## **7.6 All Other Instrumentation Systems Required for Safety**

The information in this section of the reference ABWR DCD, including all subsections, tables, and figures, is incorporated by reference with the following departures and supplements.

Figure 7.6-4a Basic Configuration of a Typical Neutron Monitoring System Division

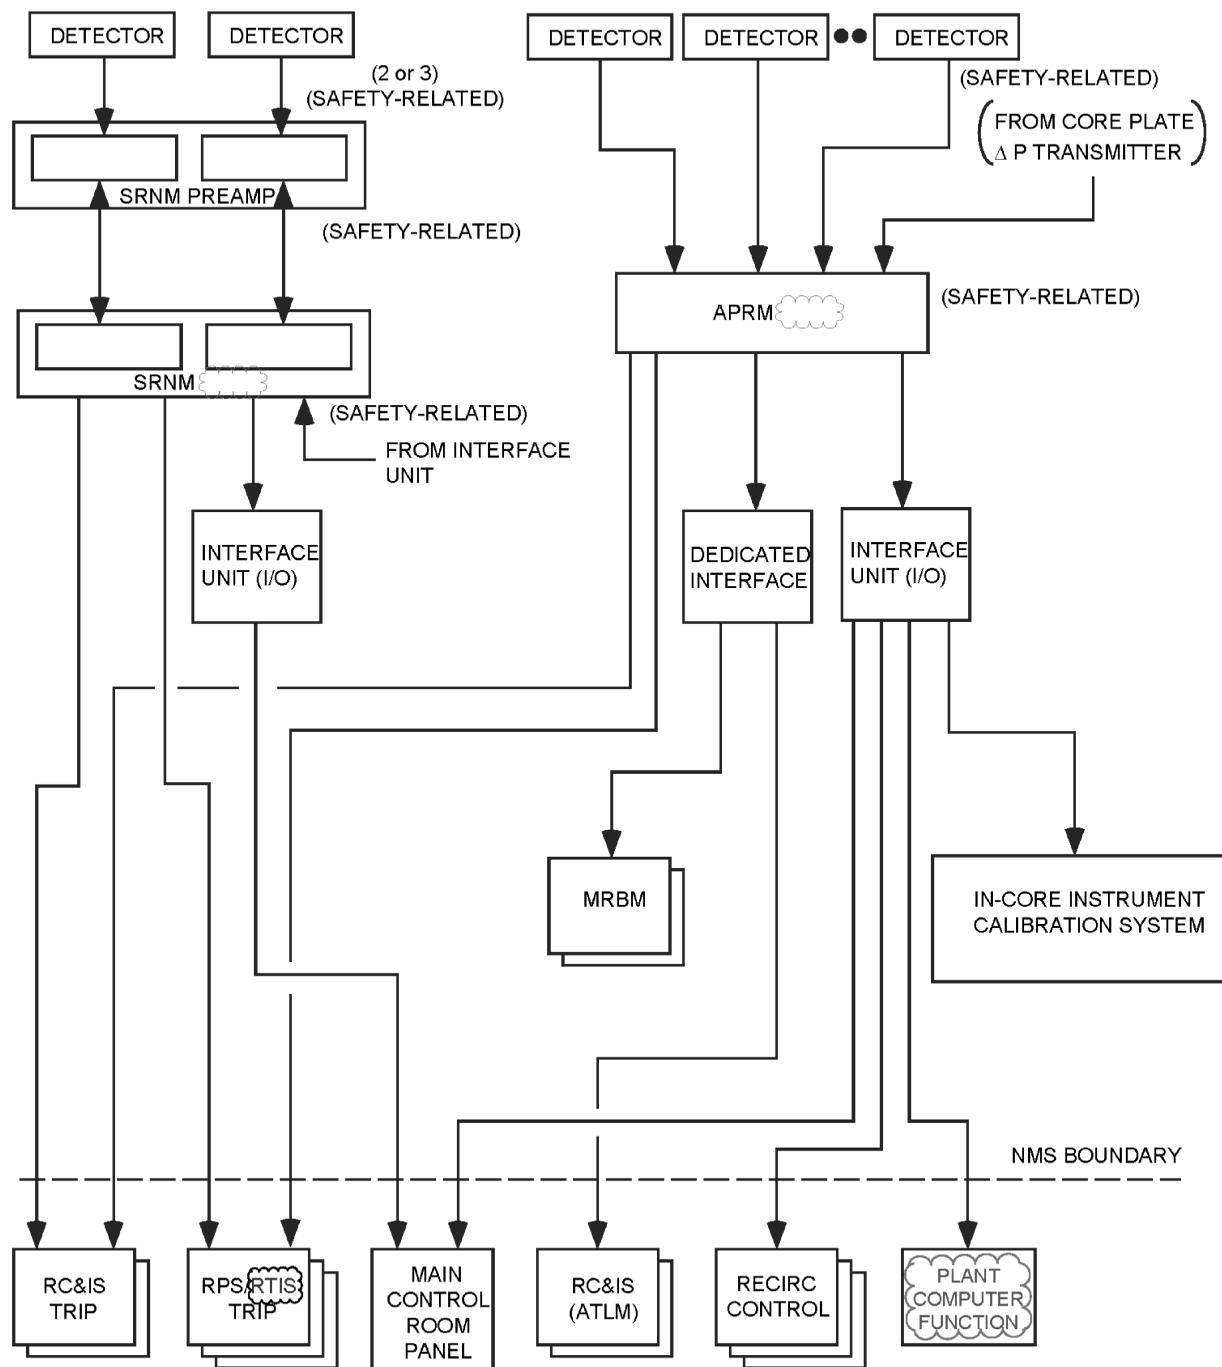
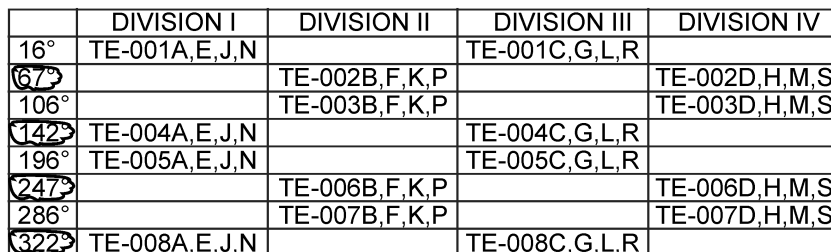
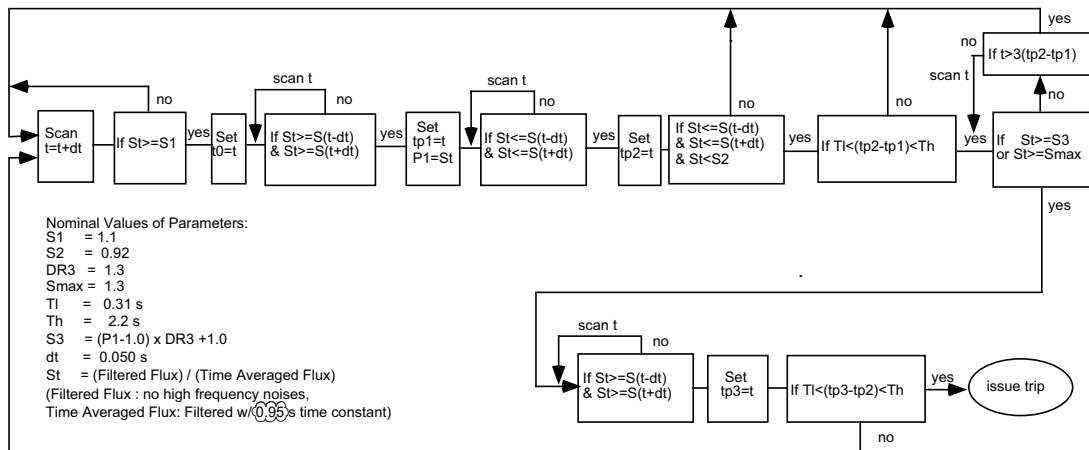
STD DEP T1 3.4-1 (Table 7.6-5 and Figures 7.6-1, 7.6-2, 7.6-4a)

*The purpose of the Neutron Monitoring System (NMS) is to monitor power generation and, for the safety function part of the NMS, to provide trip signals to the Reactor Protection System (RPS) to initiate reactor scram under excessive neutron flux (and power) increase condition (high level) or neutron flux fast rising (short period) condition. The NMS also provides power information of operation and control of the reactor to the Plant ~~Process~~ Computer System (PCS) Functions (PCF) and the rod block monitor. A block diagram showing a typical NMS division is shown in Figure 7.6-4a. The operating ranges of the various detectors are shown in Figure 7.6-4b.*

Figure 7.6-14 OPRM Logic

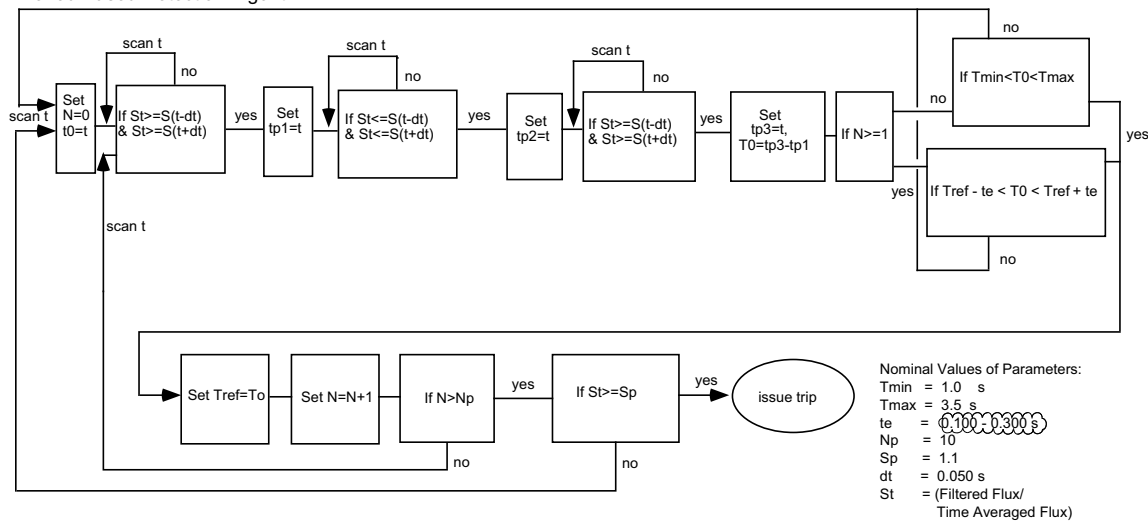
STD DEP 7.6-1 (Table 7.6-2 and Figures 7.6-2, 7.6-14)

*For the OPRM trip function, the response signal of any one OPRM cell that satisfies the conditions and criteria of the trip algorithm will cause a trip of the associated OPRM channel. Figure 7.6-14 illustrates the trip algorithm logic. ~~The OPRM trip function does not have its own inoperative trip for insufficient number of total LPRM inputs in the channel. It follows the APRM's inoperative trip of insufficient number of LPRMs.~~ The OPRM function has its own inoperative trip when the channel has less than the required minimum operable cells, when there is an OPRM self-diagnostic fault, when the APRM instrument watchdog timer has timed out, or if there is a loss of power to the APRM instrument.*
